**ADDENDUM NO. 03**  
February 12, 2010

Project: **Dickinson High School Additions and Renovations**  
Dickinson Independent School District

Bay Project No.: 0743

ADD-03-01  
 0743  
 SCALE: 1/8" = 1'-0"  
 DATE  
 M1.01

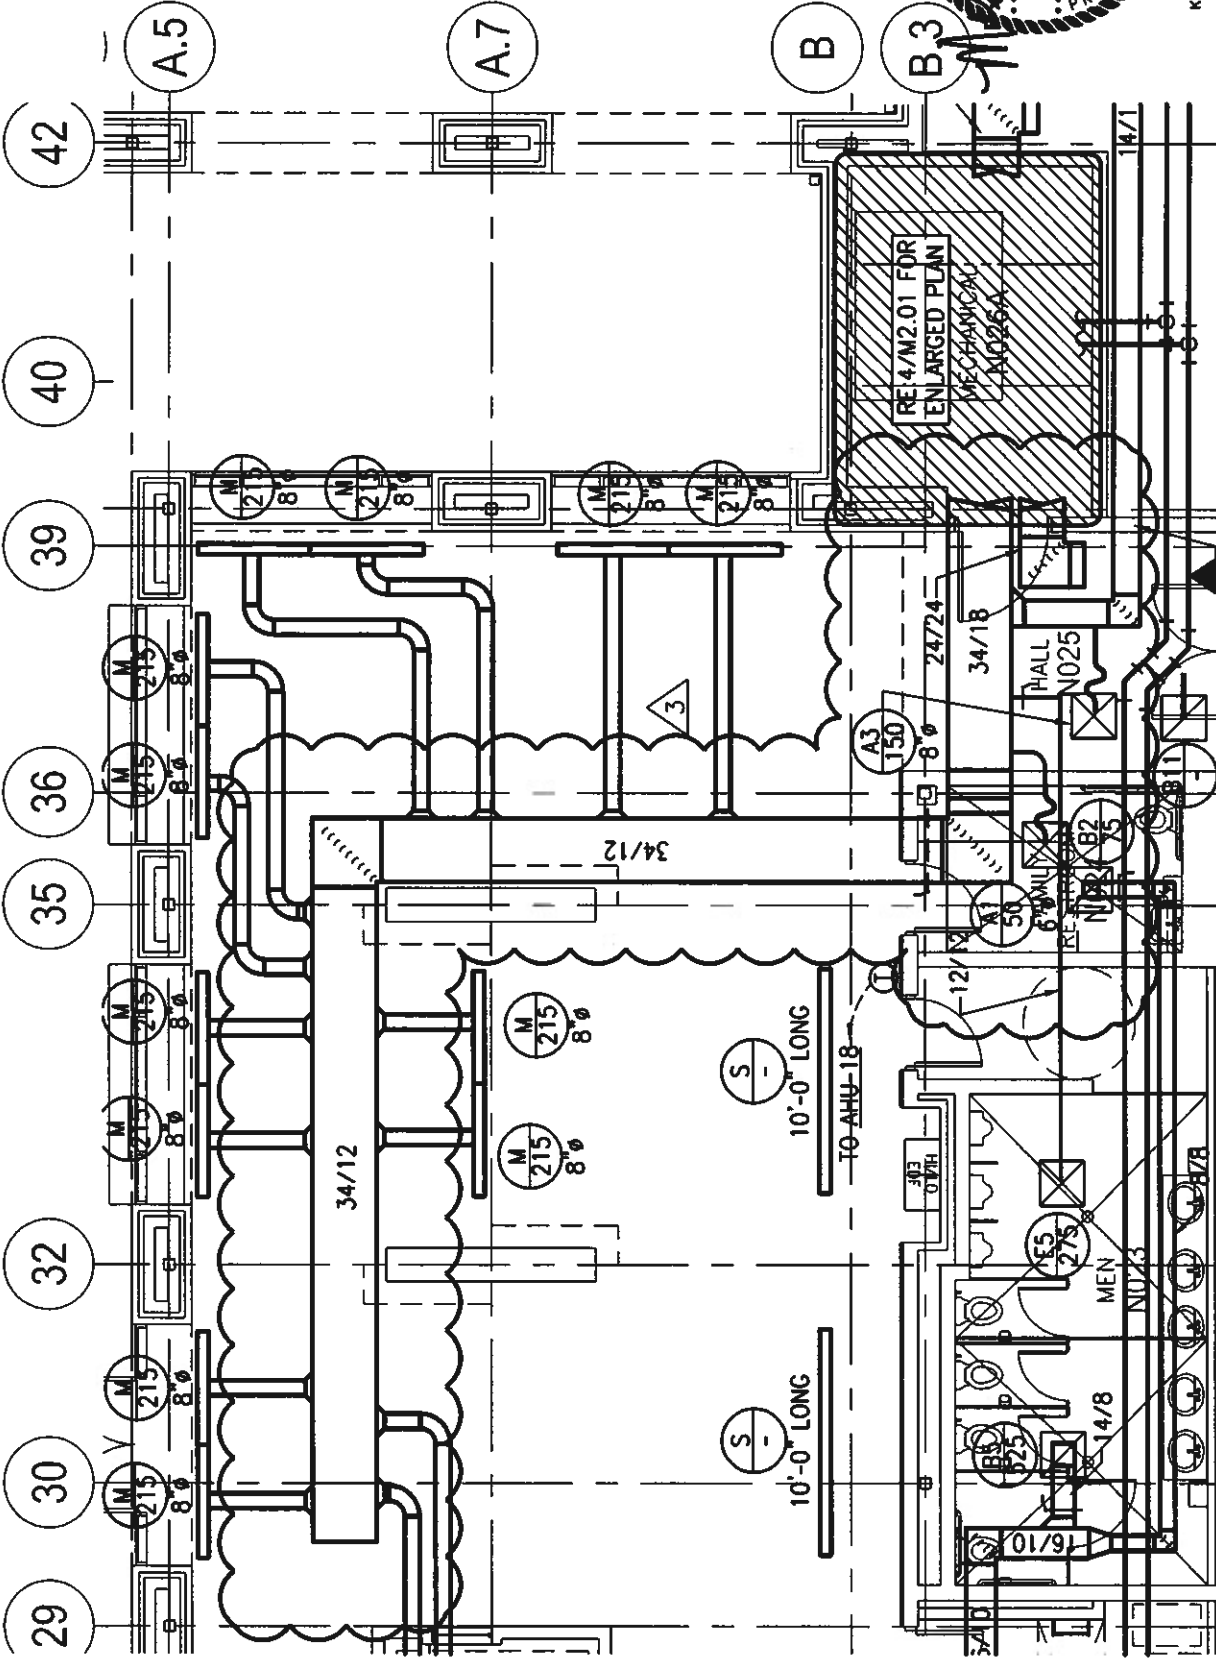
8. Sheet M1.01 – Mechanical First Floor Plan – Area ‘A’
  - a. Refer to Sketch **ADD-03-01** for ductwork revisions
  - b. Refer to Sketch **ADD-03-02** for ductwork revisions

ADD-03-03  
0743  
SCALE: 1/4" = 1'-0"  
DATE  
M2.01

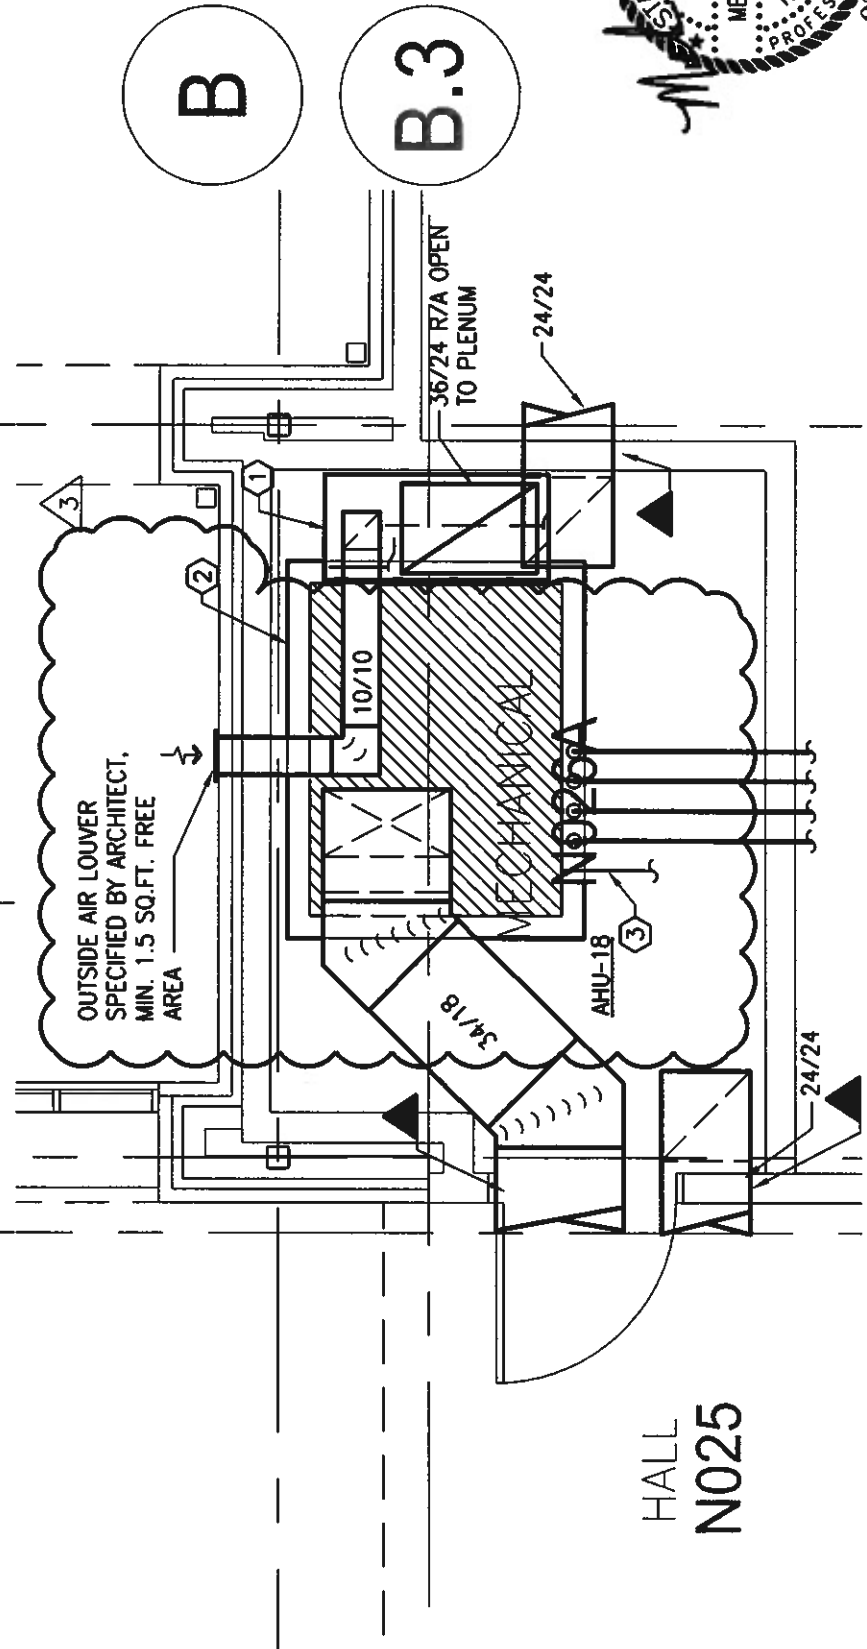
- i. Refer to Plan 2, Area 'S'. See sketch **ADD-03-12** for revisions.
14. Sheet M2.01 – Mechanical First Floor Enlarged Plans
- a. Mechanical N016A. See Sketch **ADD-03-03** for revisions to Mechanical Room.

**ADD-03-04**  
0743  
SCALE: 1/4" = 1'-0"  
DATE  
M2.01

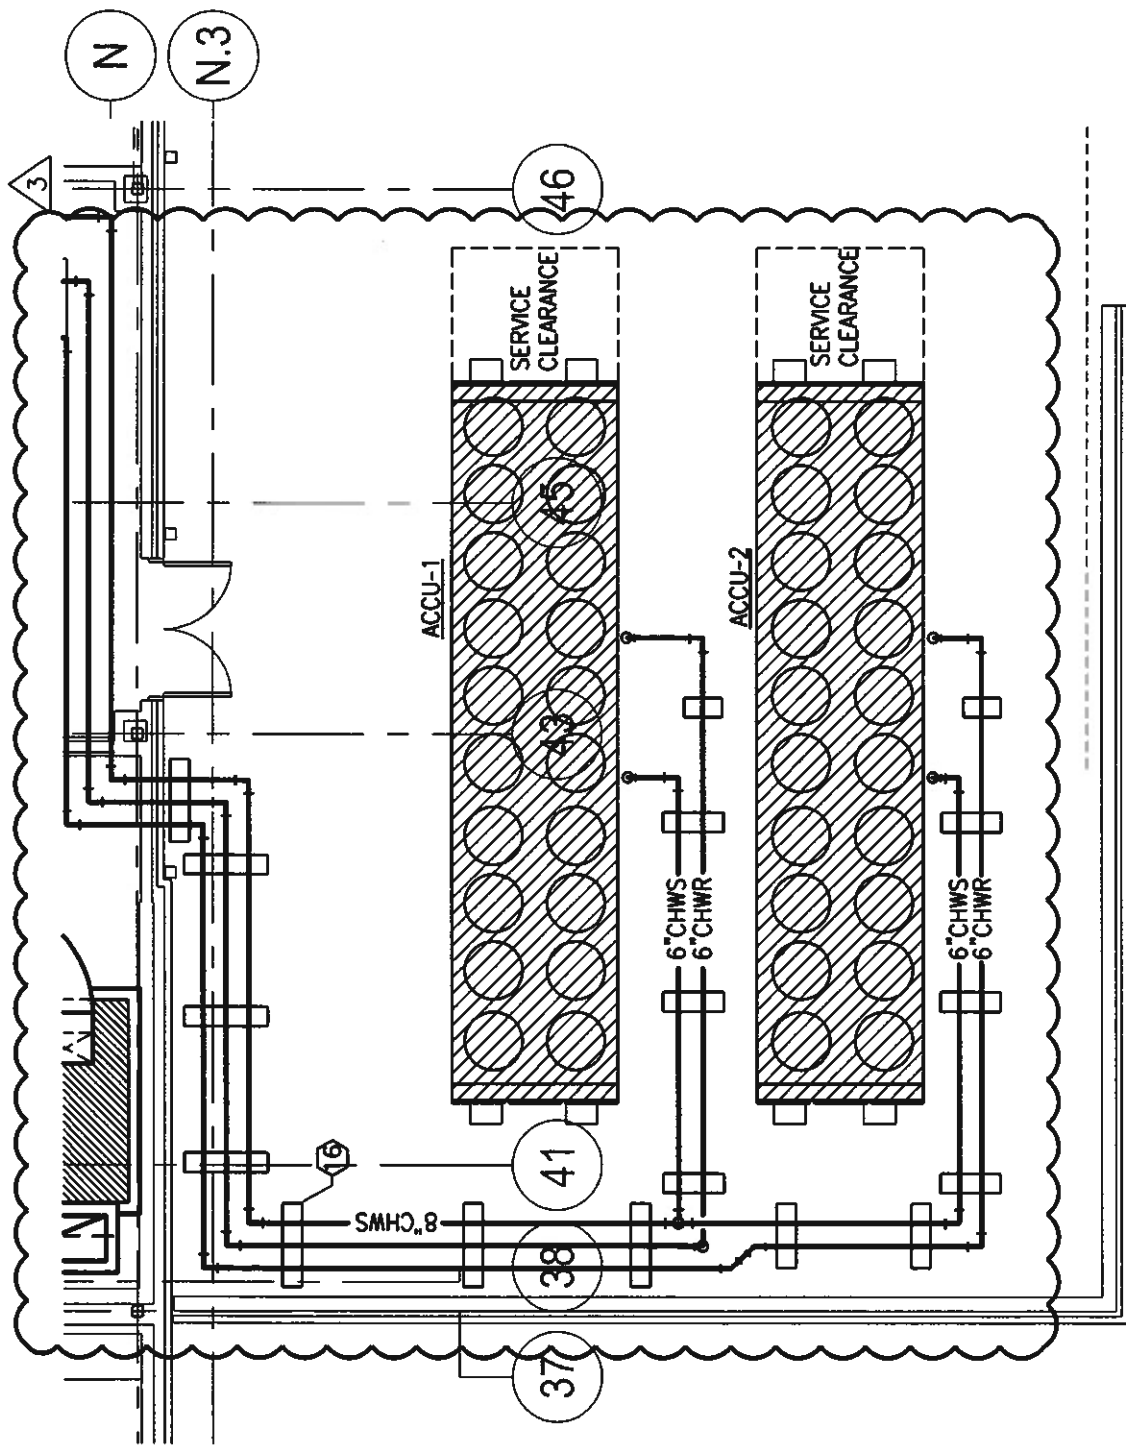
- b. Mechanical N026A. See Sketch **ADD-03-04** for revisions to Mechanical Room.
  - c. Mechanical N104, See Sketch **Add-03-05** for revisions to Mechanical Room.

ADD-03-06  
 0743  
 SCALE: 1/8" = 1'-0"  
 02/12/2010  
 M2.02

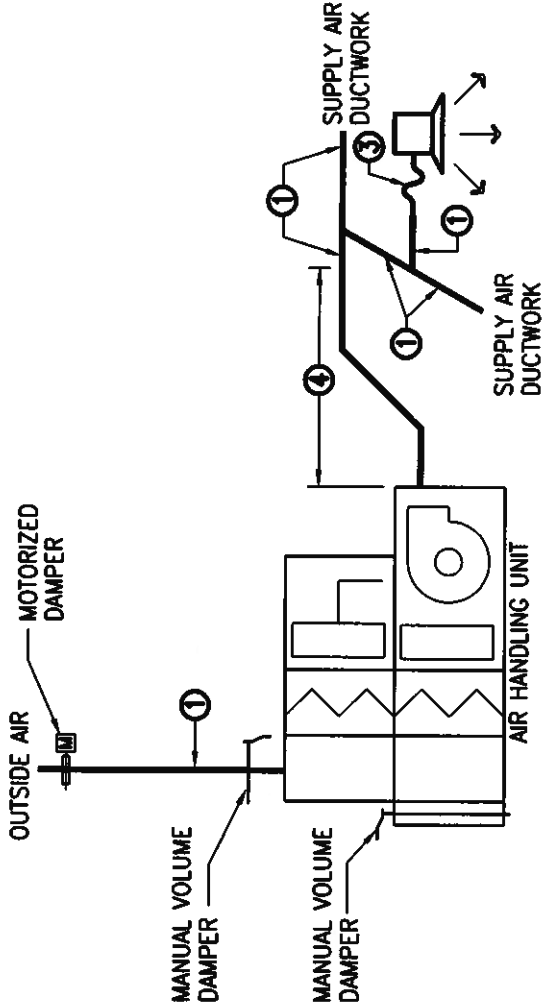
15. Sheet M2.02 – Mechanical Central Plant Floor Plan
- a. Chiller yard. See Sketch **ADD-03-06** for Chiller and piping revisions.
  - b. Mechanical N128B. See Sketch **ADD-03-07** for Air handler and ductwork revisions.

DICKINSON HS ADDITIONS & RENOVATIONS DICKINSON I.S.D.	ADD-03-08 0743 SCALE: NO SCALE DATE M4.03
--	---

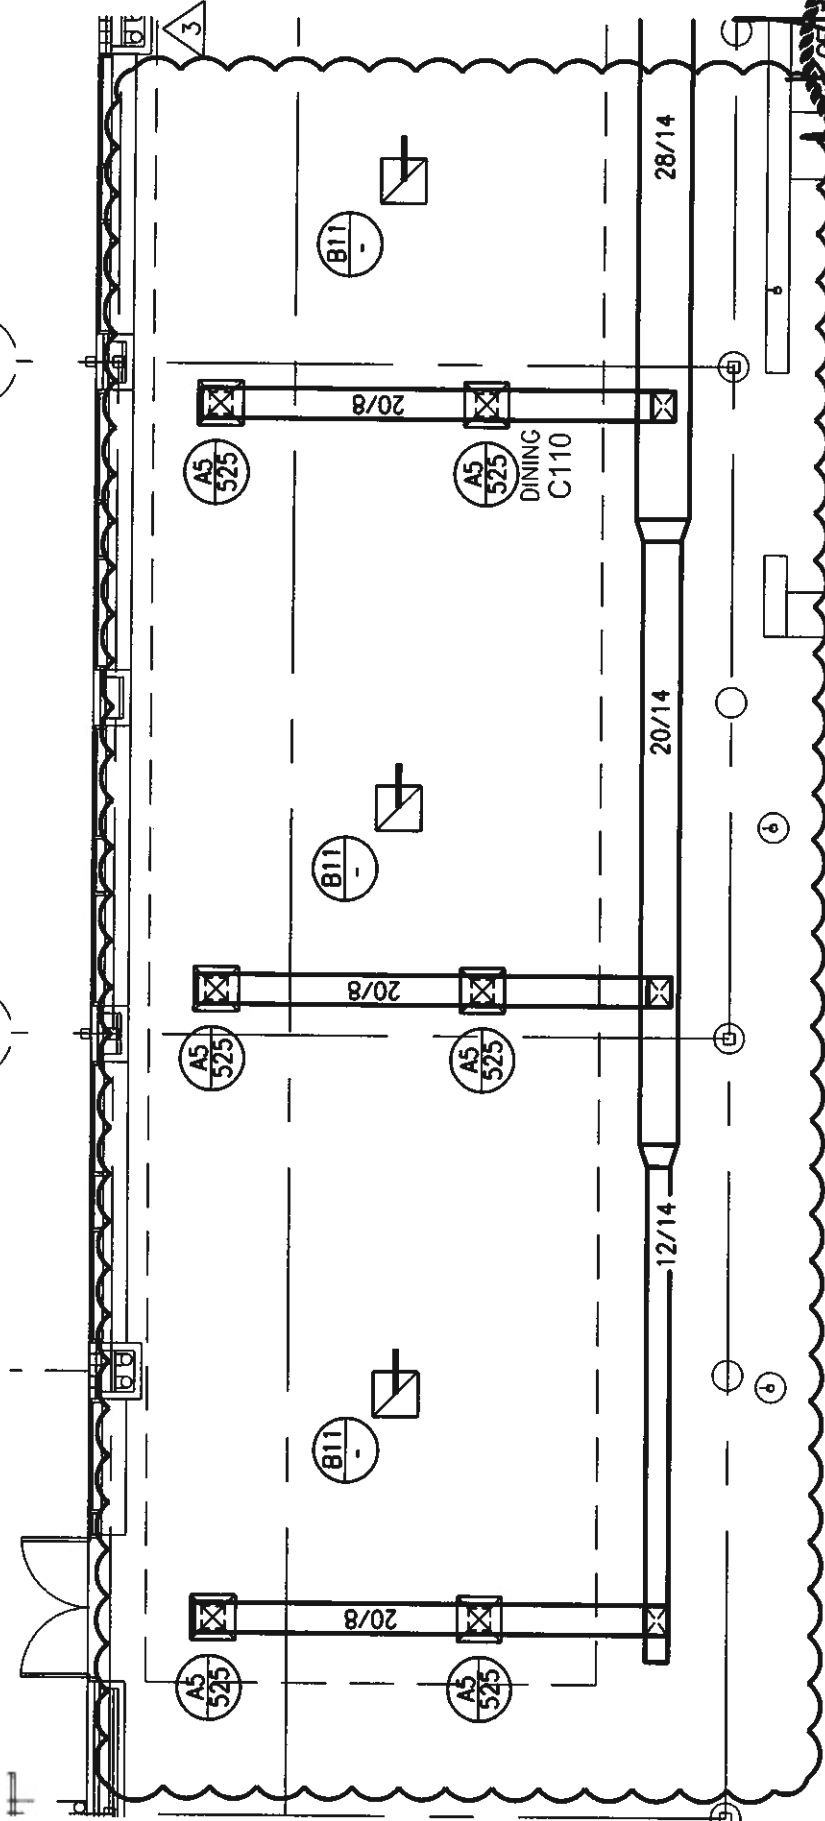
17. Sheet M4.03 – Mechanical Details
- a. Refer to Sketch **ADD-03-08** for change to Detail.
18. Sheet M5.01 – Mechanical Schedules
- a. Refer to Packaged Air Cooled Chiller Schedule.

**ADD-03-09**  
 0743  
 SCALE: 1/8" = 1'-0"  
 DATE  
 M1.12

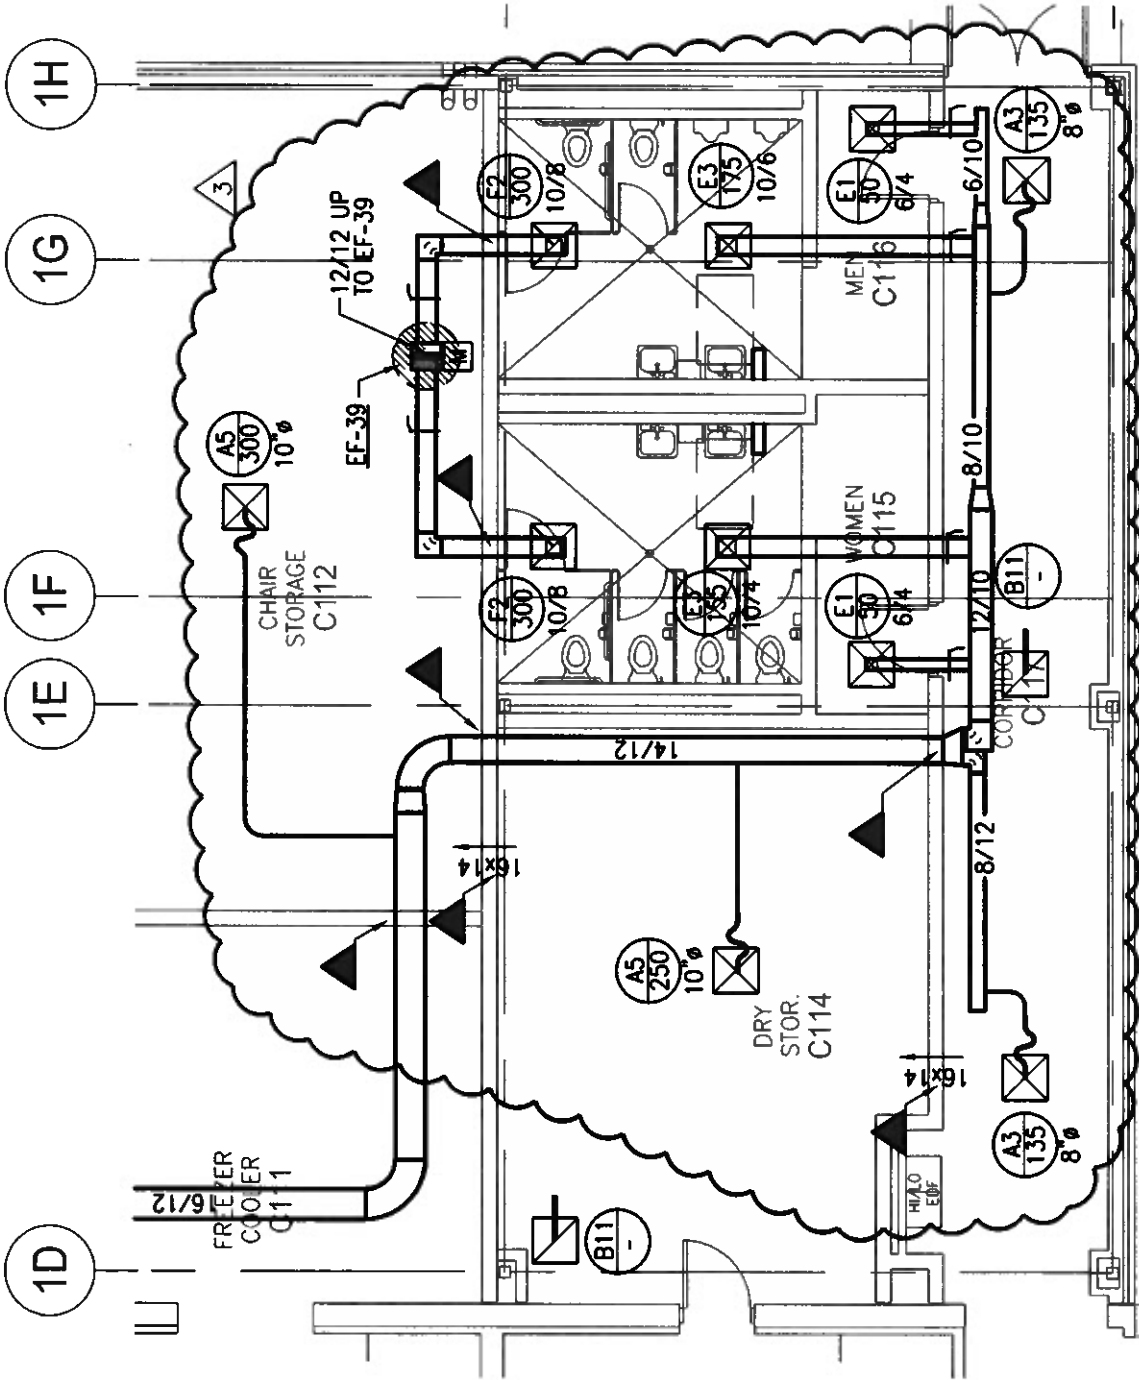
11. Sheet M1.12 – Mechanical Floor Plan – Unit ‘C’
  - a. Refer to Plan 1, Dining C110. See sketch **ADD-03-09** for revisions.
  - b. Refer to Plan 1, Dining C110. See sketch **ADD-03-10** for revisions.
  - c. Refer to Plan 1, Women C115. See sketch **ADD-03-11** for revisions.

0743  
 SCALE: 1/8" = 1'  
 02/12/2010  
 E2.04

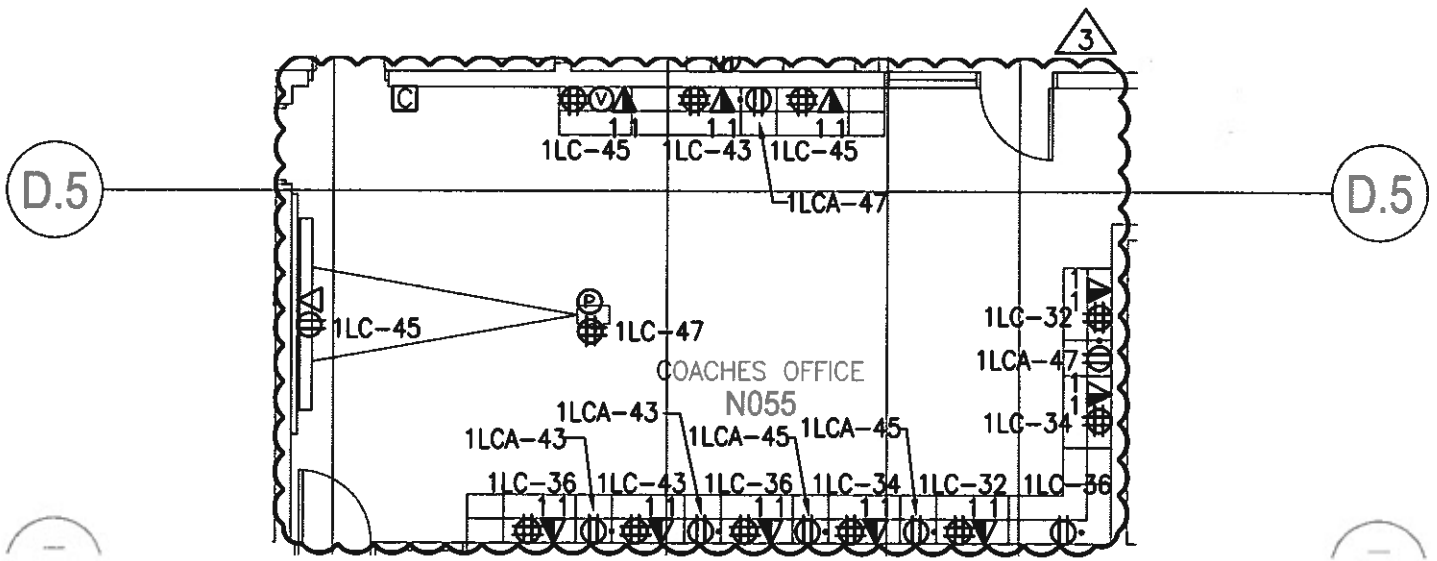
- c. LGI N002, refer to attached Sketch **ADD-03-16** for revised lighting.
  - d. Electrical Keyed Notes, revise Key Note #4 to read as follows: JUNCTION BOX FOR DISPLAY CASE LIGHTING, PROVIDE COLUMBIA #NP64-232F-FA-A12-EPU-116281 RECESSED LIGHT FIXTURE.
